**Appendix 15**  
**West Midlands Interchange Stage 1 Road**  
**Safety Audit**

In Response to: ExQ1 Number 1.7.11

# WEST MIDLANDS INTERCHANGE

Stage 1 Road Safety Audit

**Photo 2 :** Gailey Roundabout

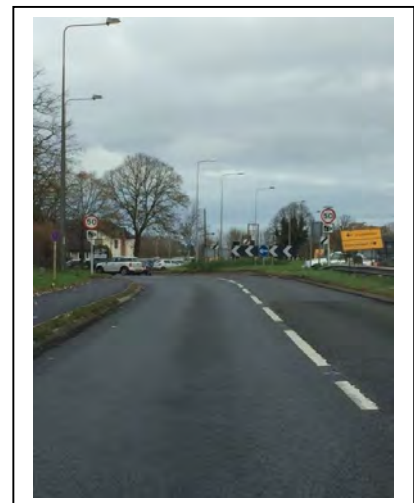
**Location :** GA 106, GA 107 – A5 including Gailey Roundabout and proposed new roundabout.

**Summary:** Proposed development of the WMI site has the potential to increase the risk of collisions on the A5, especially at Gailey Roundabout.

**Detail:** Collisions data provided to the audit team as part of the RSA1 showed high numbers of collisions, including serious injury collisions, on the A5 at Gailey roundabout (see Photo 2) and along the A5 between Gaily Roundabout and its junction with Vicarage Road. The proposed development of the WMI is likely to increase traffic flows, especially HGVs, on the surrounding road network. The A5 is a major feeder road for traffic into and out of the WMI development and is likely to encounter increases in flows. However, improvement works are not proposed to the Gaily Roundabout to help mitigate the potential risk attributed to higher traffic flows and there is a risk that the already poor collision record, will get worse.

Collision investigation be carried out on this section of the A5 (including Gaily Roundabout) and remedial measures proposed to help reduce the possibility of an increase in collisions once the WMI development is completed.
